RESOLUTION NO. 13-10

RESOLUTION OF THE TOWN OF ST. LEO TOWN COMMISSION
APPROVING PUD #13-A: BENEDICTINE SISTERS OF FLORIDA MASTER
PLAN.

TOWN OF ST. LEO STAFF REPORT
Benedictine Sisters of Florida Planned Unit Development Master Plan
PUD #13-A
Town Commission Public Hearing Meeting April 8, 2013

EXHIBIT A
PUD Site Plan

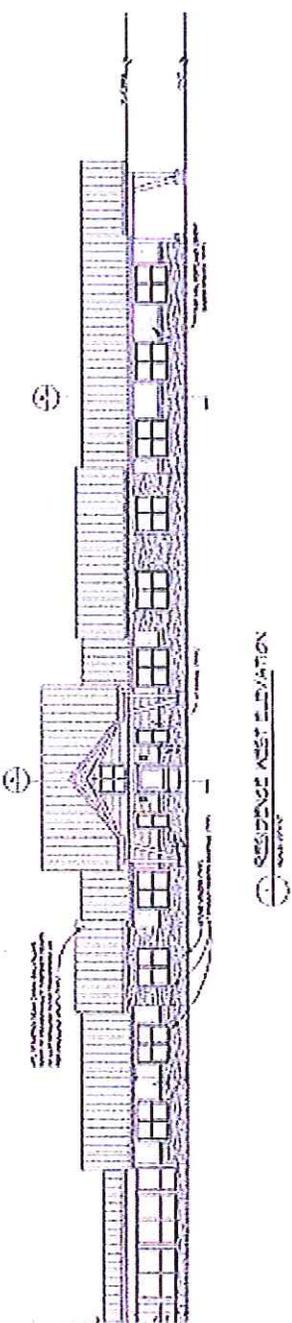
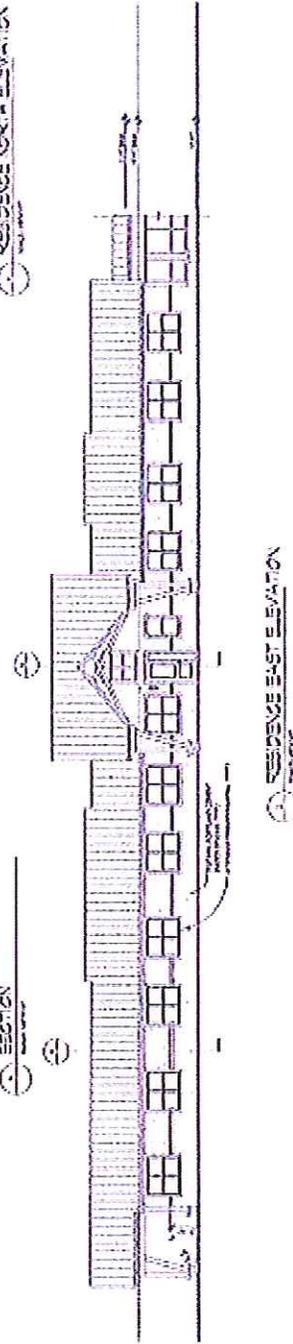
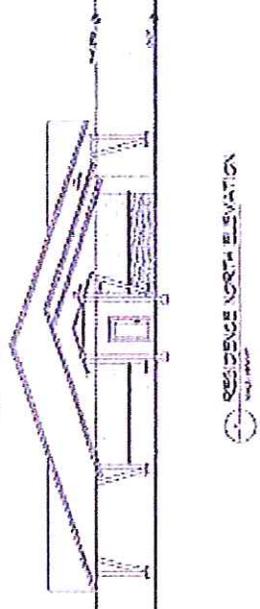
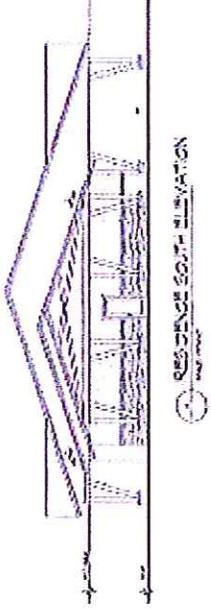
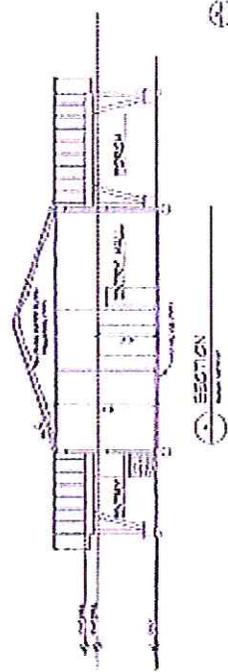
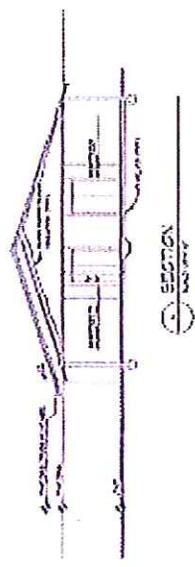
The Applicant is requesting a variance not to provide the required fence or wall along Wichers Road, but is meeting the buffer width requirement. The Applicant will also be required to submit a detailed landscape plan that meets or exceeds the planting requirements along Wichers Road. The justification provided by the Applicant has merit, as the abutting property is currently an orange grove. However, any future modifications to the PUD, in conjunction with development of the abutting site for residential use, may trigger the wall requirement.

The Applicant is requesting a variance to permit the stormwater pond to be located on the adjacent property. Since the pond will be adjacent to the development, is on property also owned by Holy Name Academy and will be a recorded drainage easement to ensure the pond will provide stormwater retention for the development; this variance request has merit.

1. A detailed landscape plan shall be provided to the Town Planning Consultant for approval prior to the issuance of any building permit for the site. The landscape plan shall address Wichers Road, parking lot, open space and stormwater landscape requirements.

2. A draft drainage easement document shall be provided to the Town Attorney and Town Planning Consultant for approval prior to the issuance of any building permit for the site. The easement shall be recorded and a copy provided to the Town Clerk prior to the issuance of a Certificate of Occupancy for the project (residences/office and chapel).

EXHIBIT B
Draft Architectural Renderings

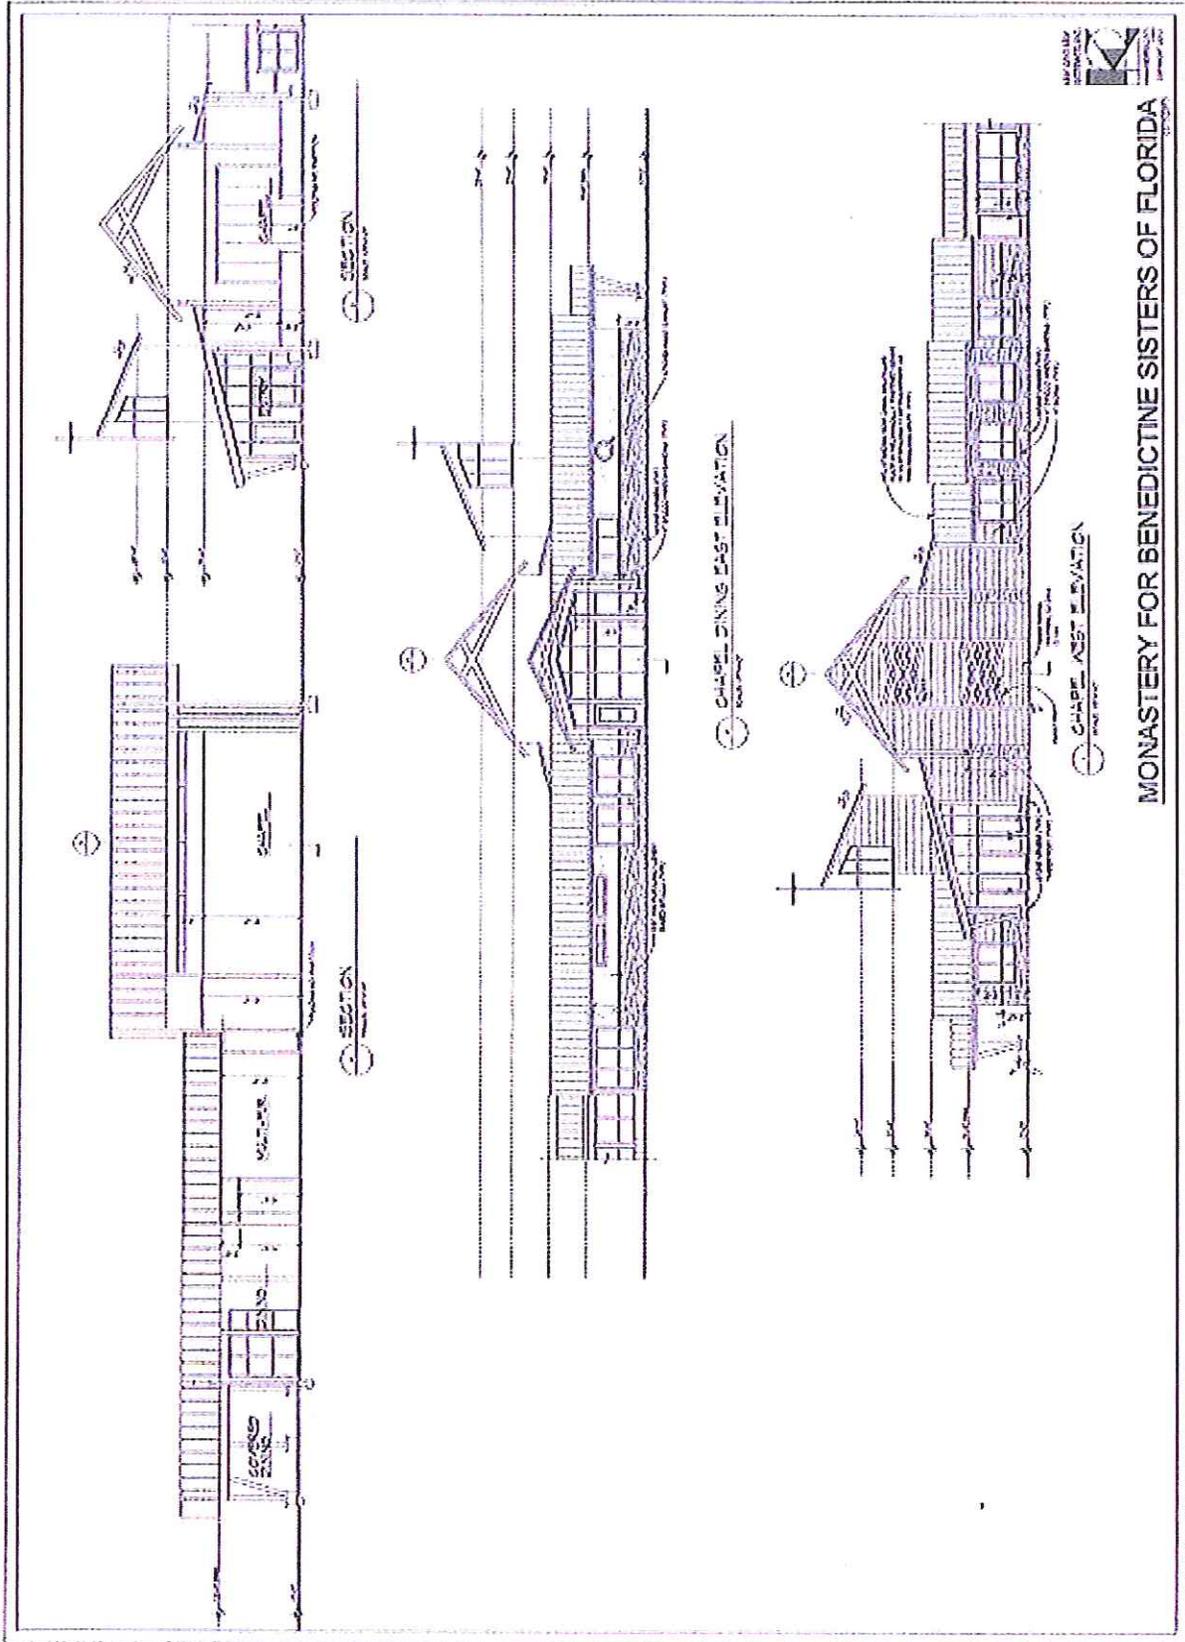
No final architectural drawings have been submitted at this time; however, the draft drawings illustrate consistent architectural design and materials for the residence building and chapel, and meet design review elements b, c, d, f and g (Exhibit B). Final architectural drawings will be required for submittal and approval prior to issuance of a building permit.

3. Submit final architectural drawings/elevations to the Town Planning Consultant for approval prior to the issuance of any building permit for the site.
